### **COMMUNICATION 132045**

Topic: Tender PW5-2020 – Value Engineering Exercise Report

Figure 4: Existing Condition at Chamber of Commerce

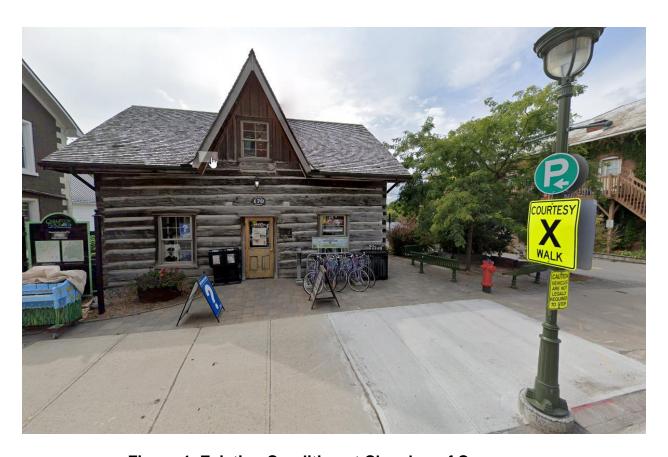
| 2. | An option was presented to eliminate the two (2) proposed gateway features at the northwest and southwest corners of Lake Avenue completely, including all monuments, flagpoles, spotlights, and planters, and retain the existing landscape features.                                | Eliminating these features will result in no improvements to the aesthetics of the Lake Avenue intersection.  | \$ 171,919 |
|----|---|---|------------|
| 6. | An option was presented to eliminate most of the proposed aesthetic improvements to the Chamber of Commerce area  | The proposed aesthetic improvements to the Chamber of Commerce were developed in coordination with the  | \$ 14,963  |

|    | located across from Town Hall. Improvements would be limited to new street furniture, and existing interlock would be preserved or reinstated instead of being replaced with new. | Stakeholder Group for this project. Refer to the Appendix for photo of the existing condition.  |           |
